## PROPOSAL FOR DRAFT AMENDMENTS TO REGULATION No. 29

(Protection of the occupants of the cab of a commercial vehicle)

Regulation No. 29  
Draft 03 series of amendments  
OICA proposal

Fig. 1

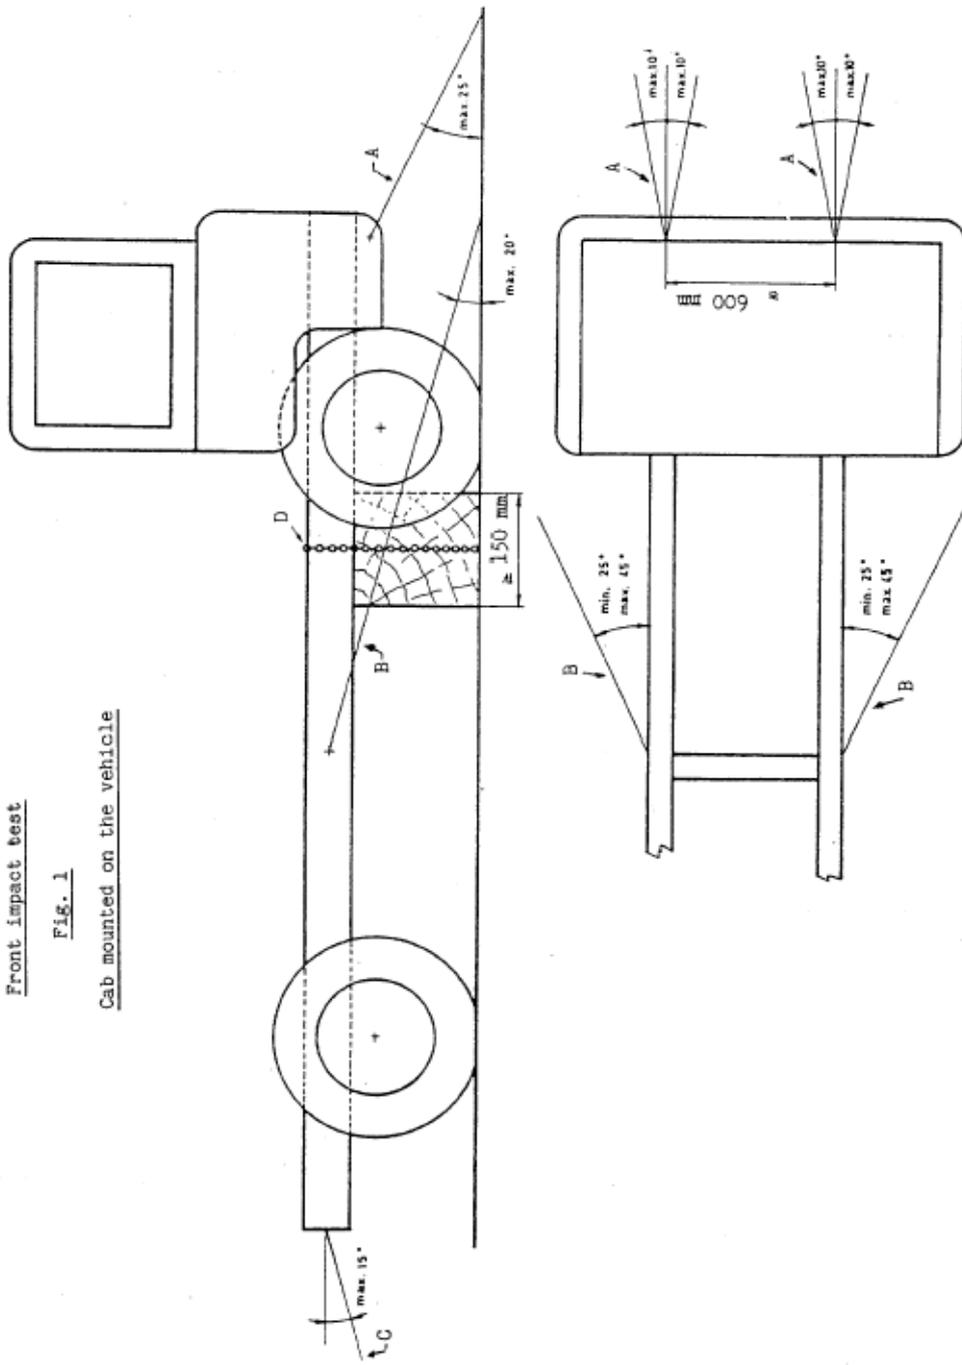
The chain or rope C shall to begin with be placed under a load of approximately **1 kN** ~~400 kgf~~. All slack in the four chains or ropes A and B shall then be taken up and chain or rope C shall be subjected to a tensile stress of not less than **10 kN** ~~4,000 kgf~~. The angle of chain or rope C with the horizontal shall not exceed 15°. A vertical blocking force of not less than **500 N** ~~50 kgf~~ shall be applied at point D between the chassis frame and the ground.
